State of Alaska
Department of Environmental Conservation
Village Safe Water Program

Re: Amendment 5
ITB 24-VSW-PTD-007
Port Alexander Water Tank and Foundation Replacement
ITB Due Date: November 7, 2023 @ 2:00 PM AST

The following are vendor questions and the department's response:

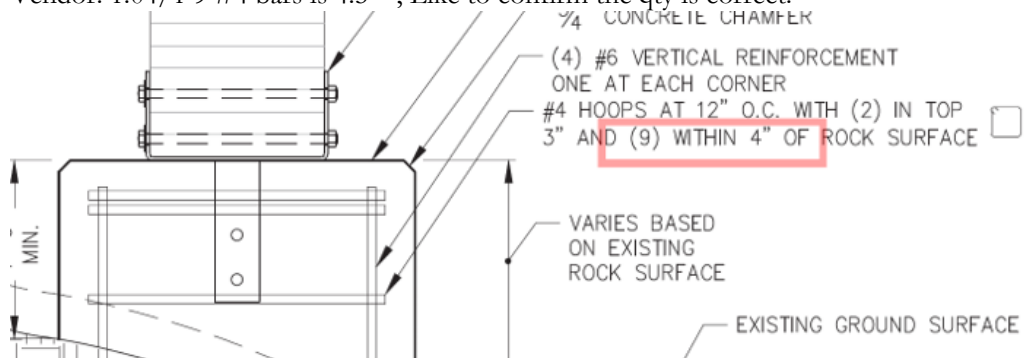
2. Vendor: 1.04 / 1 The plan view appears to show 2 diagonal braces between each adjacent pier (both ways) on each side of the post. 1.06/ A Elevation shows only 1 diagonal brace between each pair of piers. The elevation makes it appear the downward sloping ones are on the backside whereas the positive sloping ones are on the near face with the opposing face devoid of the additional bracing the plan view shows. Should the red be added?

Department: Bracing is as shown in the plan. Elevation omits the second brace for clarity. See attached updated drawing sheet 1.04.

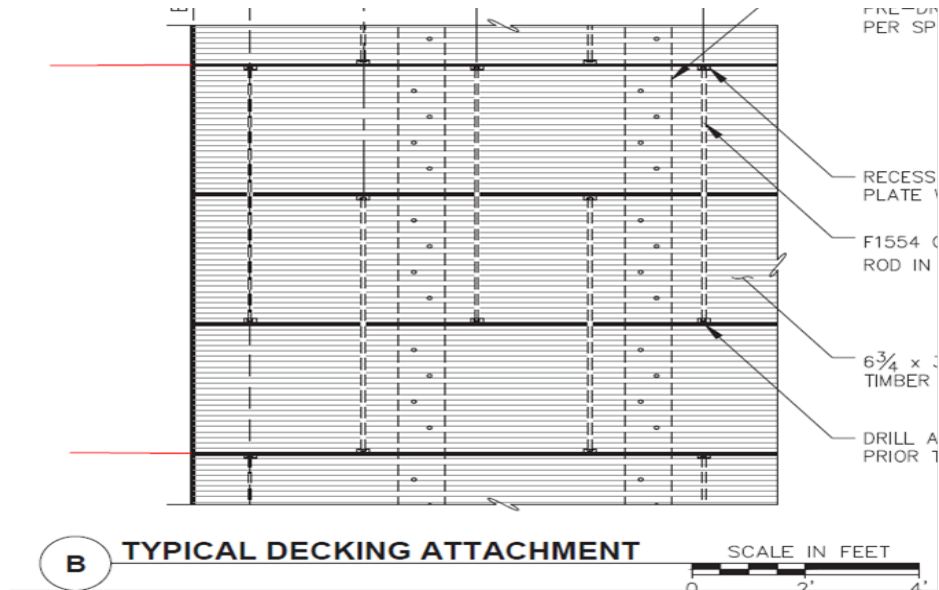
3. Vendor: 1.04/1 9 #4 bars is 4.5 “, Like to confirm the qty is correct.

Department: Update quantity of hoops within 4” of rock surface from (9) to (2).

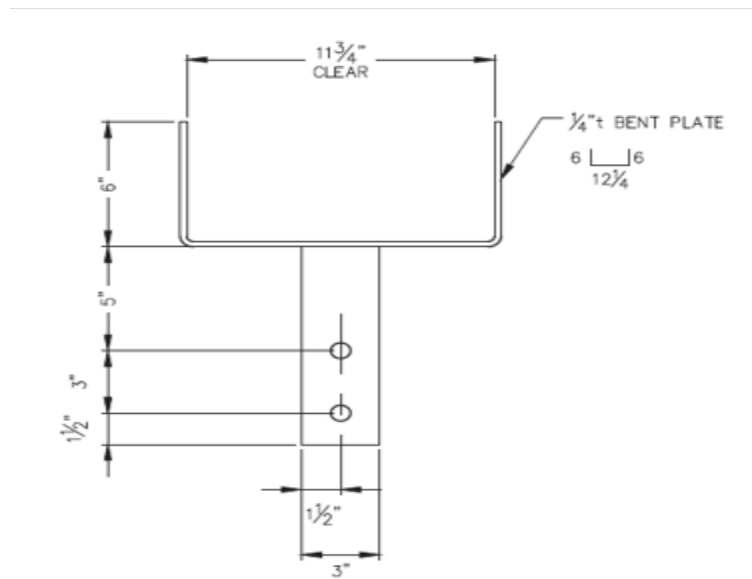
4. Vendor: Det 1.06 B Like to confirm the intention for the deck glulams is that three are bolted together and act independently of the adjacent three? Within the diagram no rods appear to pass through the red lines. If grouping in sets of 3 is correct, should the 2' unit outside of line I be added to the adjacent 3'?

Department: Rods shall create a continuous connection. See attached updated sheet 1.06.

B 1.05 Which shows bolt spacing has the beam height as 18" and the bracket height at 8.

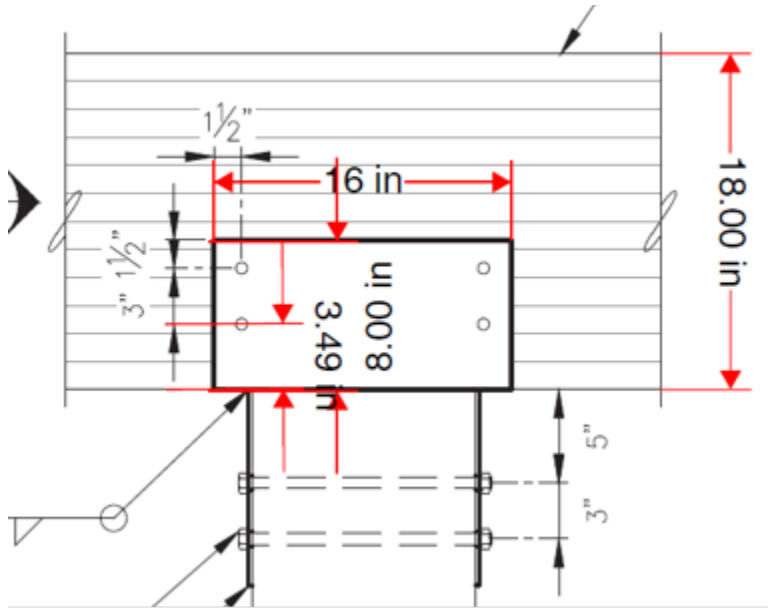
5. Vendor: I had been scaling the beam off the 6" bracket height shown in 1.05/F which resulted in the shorter height. Using 1.05/B's 8" (assume preferred design) the stringers scale at 18".

Department: Update bracket height to 8" and width to 16".

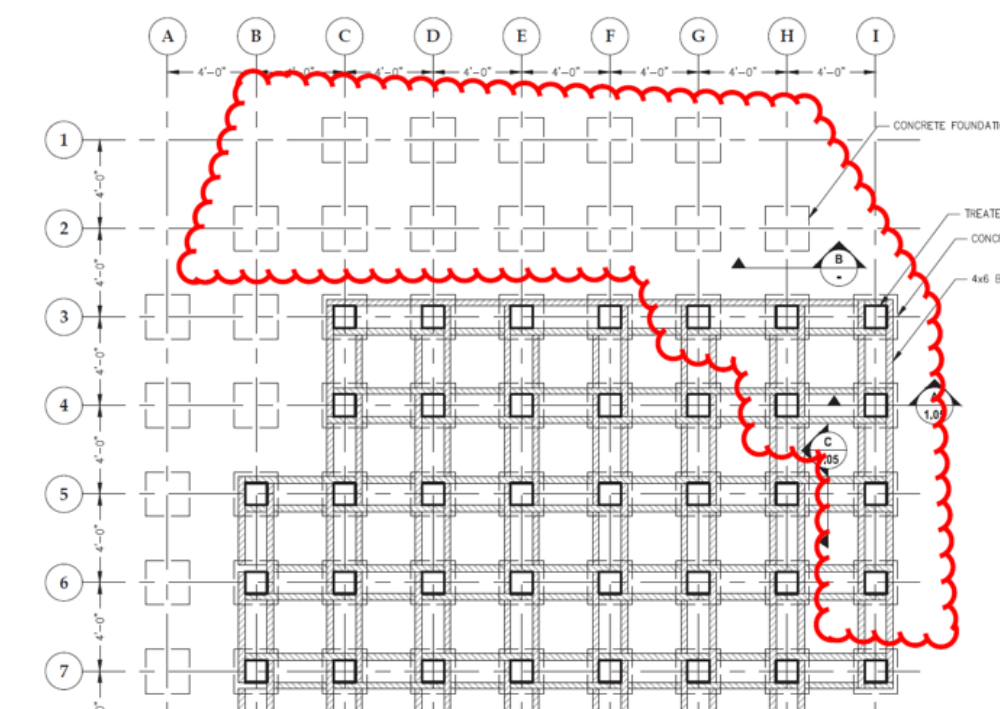
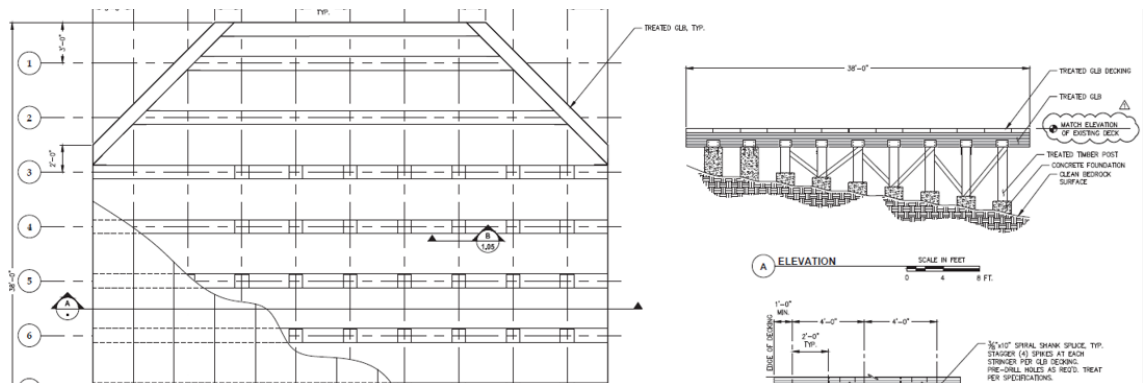
9. Vendor: It appears that on the tank's west side there are some tall concrete piers not X braced and on the east side the posts may be so short that the 4way X bracing would be difficult to install. Certainly there will be variations in the bedrock elevations but it seems odd that the piers are almost a mirror image about GL E between the two projects. The orientation of the two projects seem to be the same with the tank inlet being at the top of the page.

Pages 2/3 (PDF 15,16) of the asbuilts

The 3 concrete piers (red box) in elevation A-A seem to tie back to the plan view on as built page 2 (PDF 15). Virtually all the concrete piers are either on lines 1 and 2 or H and I above the 320' contour. The revision cloud is what I believe were the '86 concrete piers above EL >320

Page 1.04 which details today's pier type by gridline matches up with the original drawing with GL rows 1 and 2 being concrete. I have copied the rev cloud to the new drawing to show the difference between lines A&B and H&I.

Department: Bidders shall use layout from PND drawings. The department cannot speak to the previous project, but it appears the contour lines are consistent with the grade prior to excavation to bedrock and the piers were modified during the previous project to match the bedrock contour, which is different than the contours shown in the original design drawings. The contractor shall field verify column and pedestal heights prior to construction. Below is an image of the side of the existing tank foundation which shows the existing conditions use a timber post instead of the concrete beam support as shown in original drawings. Note the location of the overflow piping is located per the original drawings.

The contours in the original drawings are believed to show ground surface before excavation to bedrock. The bedrock generally slopes from the inlet to the outlet of the tank with some cross slope across the site, with the high end being to the west. Perspective bidders are strongly encouraged to visit the site prior to bidding.

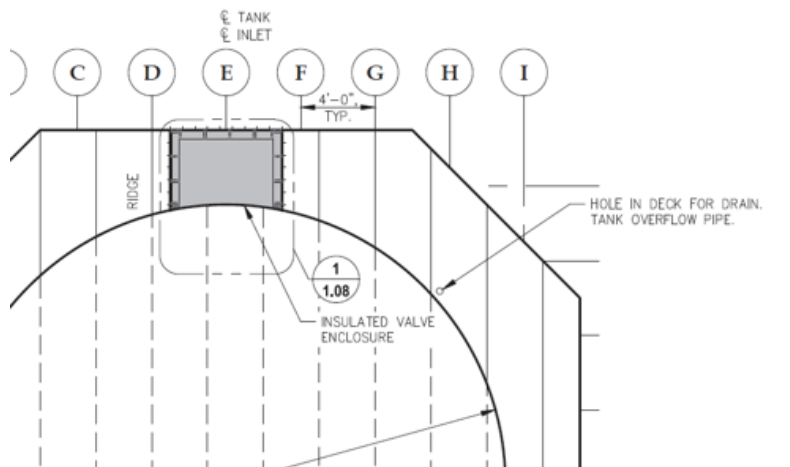
1.06 Cross section A looking north has the concrete piers on the left side (actually GL 5 should only have 1 concrete pier and the rest should be posts) with the ground sloping down as you progress from GLs A - I. The asbuilts from above seem to show that the ground actually slopes upwards (from 316.75 to 320.5) the further as you progress A-I.

Page 1.07 Inlet orientation looks the same from the north, the new drain is in the NE corner which matches P 1.14 below.

B 1.05 TYPICAL COLUMN TO GLULAM STRINGER SCALE IN INCHES 0 6 12 IN

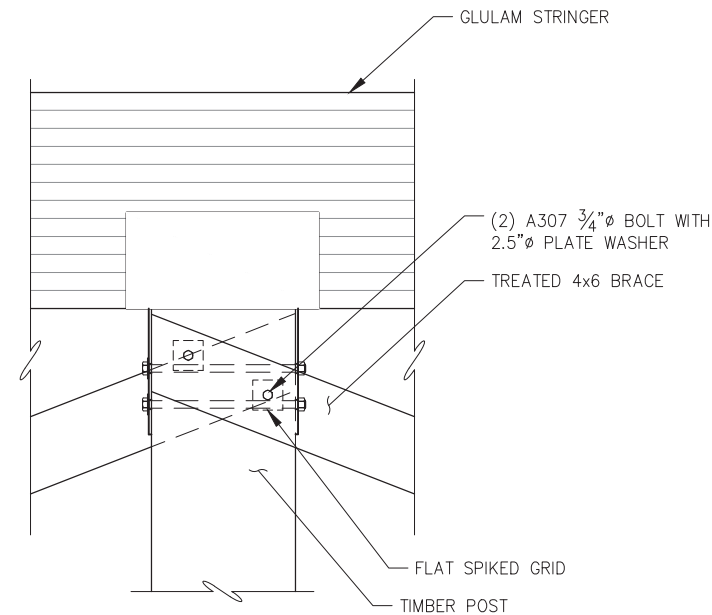
1. Vendor: Like to verify the stringer height of 18" scaled off 1.05B is correct. Believe the bracket leg should be 8" ILO 6".

Department: All GLB stringers are 12.25 x 15. Update leg height to be 8" instead of 6". See attached updated drawing sheet 1.05.
